**From:** danny@pwllc.net  
**Sent:** Tuesday, May 30, 2017 2:27 PM  
**To:** McMillan, Michael, EMNRD; Kautz, Paul, EMNRD  
**Cc:** Bill Prichard  
**Subject:** SWD-1594-B Raz Oil & Gas, LLC's YO State SWD #1 (30-025-38162)  
**Attachments:** YO State SWD #1 Rev Wellbore Diagram 053017.pdf

# PROPOSED WELLBORE

YO State SWD #1

API# 30-025-38162

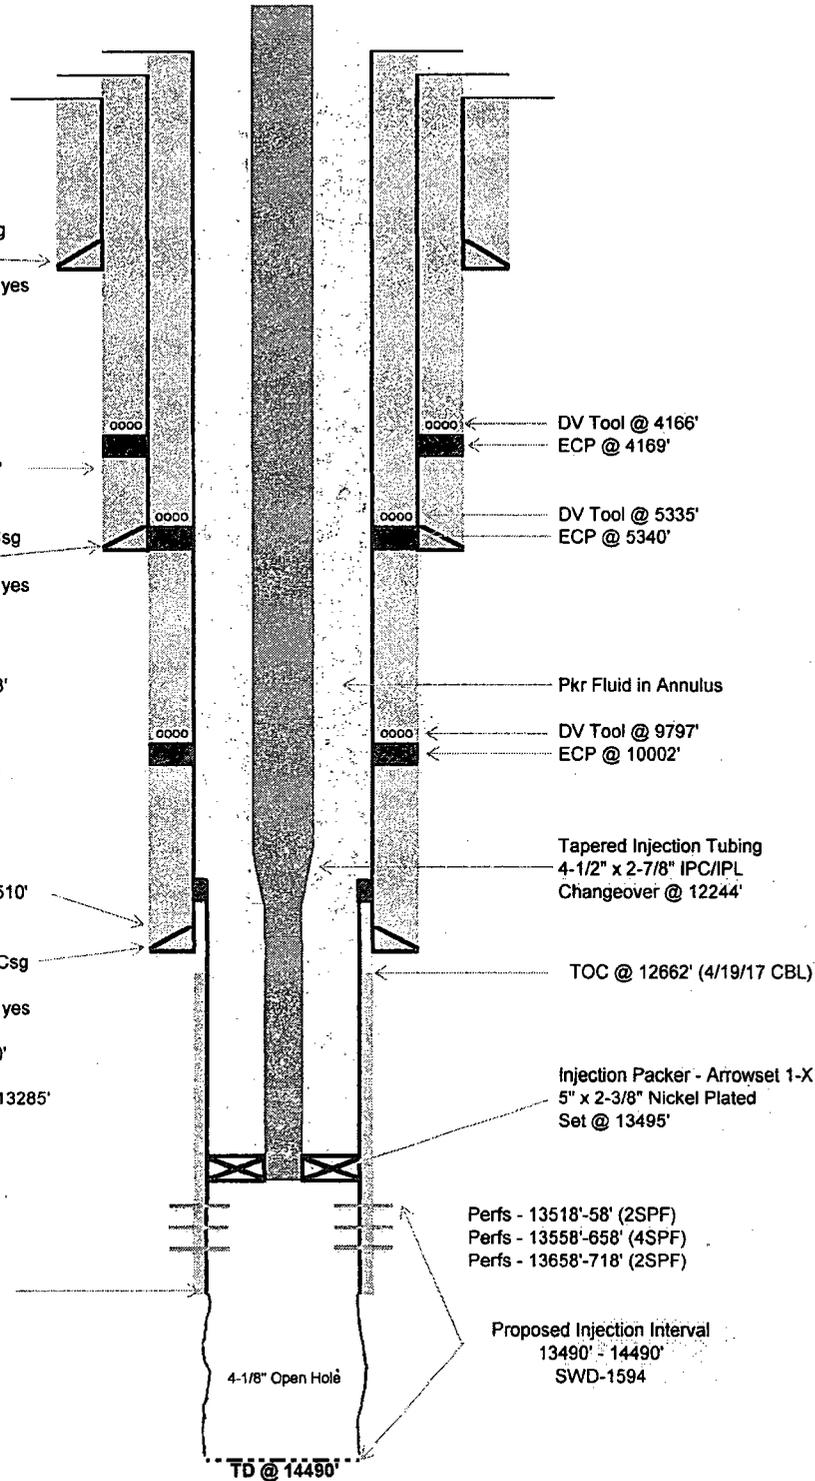
Michael and Paul,  
Raz Oil and Gas, LLC requests approval to deepen the injection interval on the referenced well. They propose to deepen the well an additional 522' from the current TD of 13968' to a new TD of 14490'. That would change the injection interval from 13490' - 13968' to 13490' - 14490'. The base of the Devonian is expected to be around 14700'. The resulting completion would be a combination of perforations in cased hole and open hole below. This proposed new completion would still be several hundred feet above the Ellenburger formation. Attached is a new proposed wellbore diagram reflecting this request.

This request is necessary as the completion of the permitted interval (13490' - 13968') found decent porosity, but would not take water. Raz has acidized the interval twice with no improvement. As a result, they request to deepen the well in search of better Devonian porosity.

There would be no change to the top of the injection interval. There would also be no change in the list of affected parties. Michael, upon approval of SWD order amendment, Raz will file Notice of Intent with the District Office to deepen the well.

The Engineering Bureau will approve the change in injection interval and completion with the following stipulations.

- Before injection, the OCD Engineering Bureau and Hobbs District Office must receive a mudlog ,summary description of log tops, and well logs (if ran).
- The approved administrative order only allows injection into the Devonian formation only. Therefore, injection into the Montoya formation is prohibited.
- If the well penetrates the Montoya formation, it must be plugged back.

I can conditionally approve a C-103 to depend the well. The conditions of approval will be conditional on Santa Fe approving a change in your injection interval.
